Reply to comments of RC1 and RC2

Table B.1 – Test site requirements: topographical variations

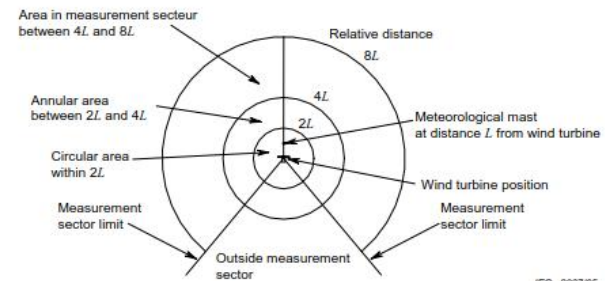
Where are the 10 heights measurements (including the topology of the terrain) ?

The site is flat (ie. It is flat in accordance to the requirements of table B.1 of annex B of IEC61400-12-1). A reference to a report on 10 year boundary layer meteorology at Høvsøre will be included in the paper.

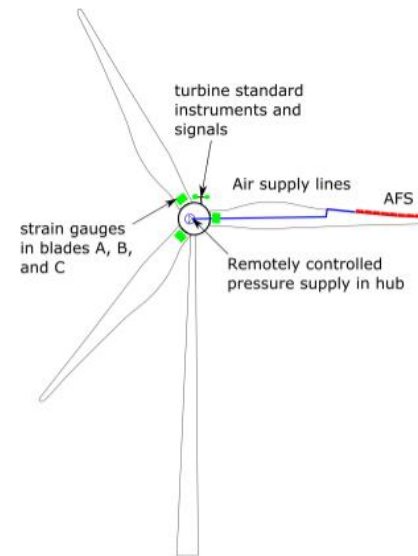
This is particularly annoying to evaluate if the targeted objective (load control) is reachable. The needed time response of the system for load control (due to shadow effect) seems to be not reachable from the present system. Delays come from the whole control system arrangement itself, one order of magnitude slower. Indeed, this can't be the time response of aerodynamic loads which is faster, of the order of 0.2s (for 1.25m blade chord and a relative velocity of 60m/s). Moreover, this delay does not include the whole system:

Question 6: A more detail description of the actuation system with the tubing arrangement (including the valve type, dynamic characteristics) should be included to at least evaluate what objective can be reached by this control system.

Therefore, the system is currently responding according to the physical limitations of the setup, including the pump capacity for air supply, as well as the gas dynamics of flow compression and viscous losses in the supply pipes (which are located inside the blade as the sketch below shows.

Reply to question 6: Yes, due to conciseness and page limitation, the reader is referred to the publication mentioned. All pneumatic components are placed in the hub. Air is supplied with a two pumps working in parallel of type Parker T1-2BL-24-1NEA. The valves used for control are in a 3/2 arrangement made up of 2 valves of type SMC VXZ24OFZ2AA 1/2", one in NC configuration and the second one in NO configuration. This will be mentioned in the paper.

Figure 2.2: Van der Hoven spectrum (1957) as drawn by Alan Davenport (Isyumov, 2012).

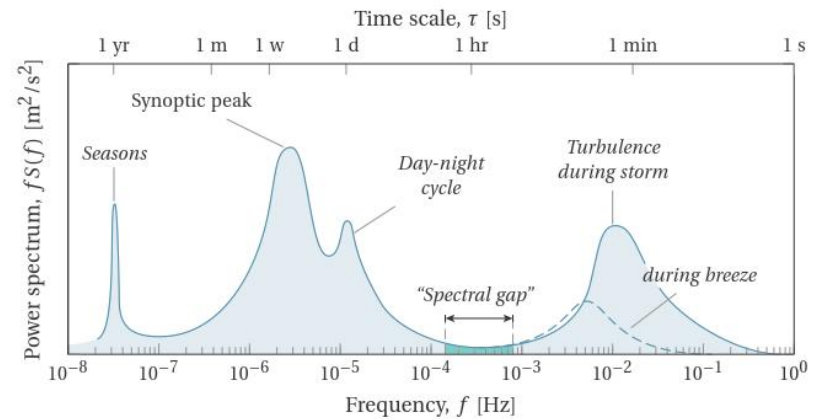
<p>Question 11: There is certainly limitations that are linked to the statistical convergence of data, which is certainly dependent on the coherence of the turbulent wind field contrary to what is said in the text. In other terms, why 30 min and not 1hour, 2hours, 1 day ... for your statistics ? Have you looked on how the statistics converge towards the final value ?</p>	<p>Reply to question 11: For standard power and load measurements, intervals of 10 minutes are used as this normally covers the turbulence power spectrum of small scale atmospheric turbulence (see Van der Hoven spectrum below). 1 day is not chosen because you would have a</p>

clear day-night cycle in the data set. 1 hour or 2 hours could have also been options. We intended to gather a higher number of transients, therefore we chose 30 minutes instead of periods of 1 or 2 hours. We chose 30 minutes, and not 10 minutes (which else would have been standard), in order to avoid having a significant impact of the transient behavior on the steady state values. I will comment this in the paper.
